cc: Jonn Jackson
Subject: FW: Waters Edge Close, Whitehaven - High Road (Rhodia) - 4200008300

Email below from United Utilities with notional approval of principle being discussed.

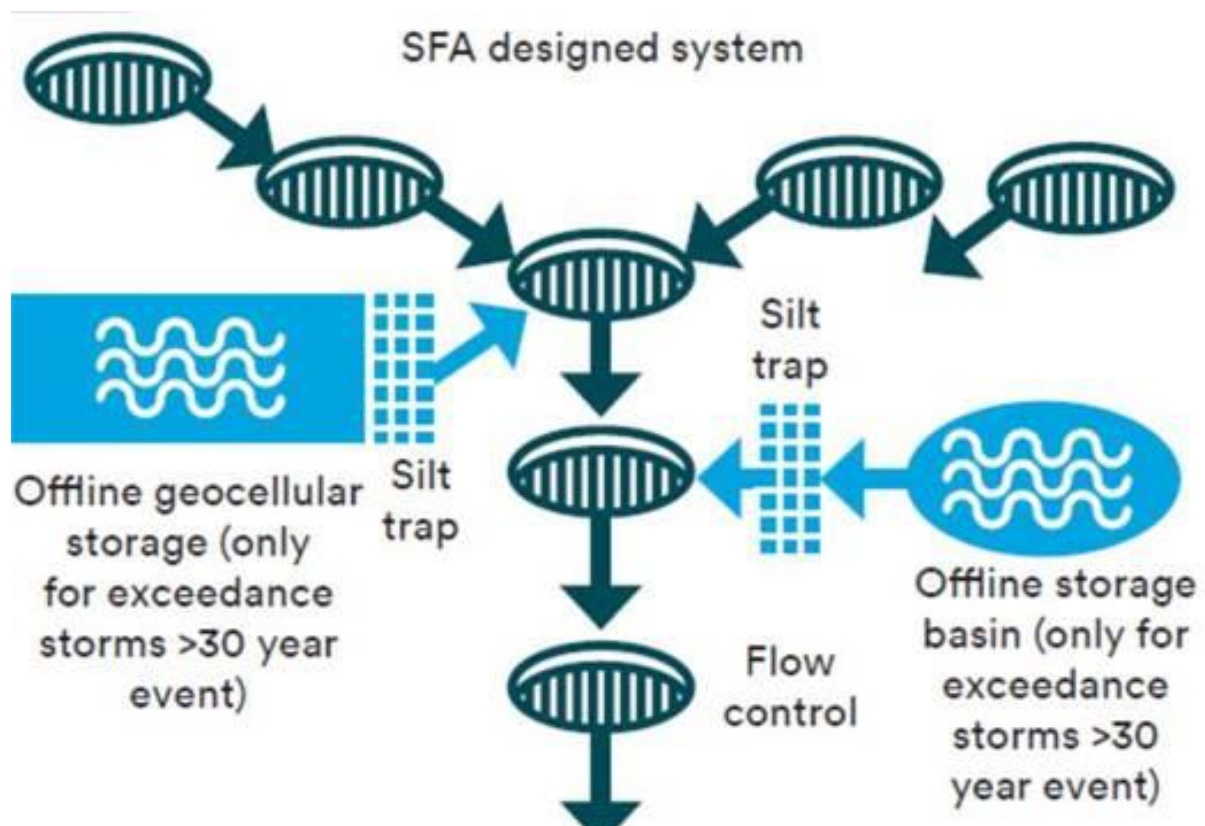
- The proposed position of the new basin in Phase 1 would require the diversion of the 2 pipes under agreement out into the public highway as they cannot be near / under 100 year storage systems (basins or cellular). They will have easements for this reason , so no private storage can be within this area (see below for typical example)
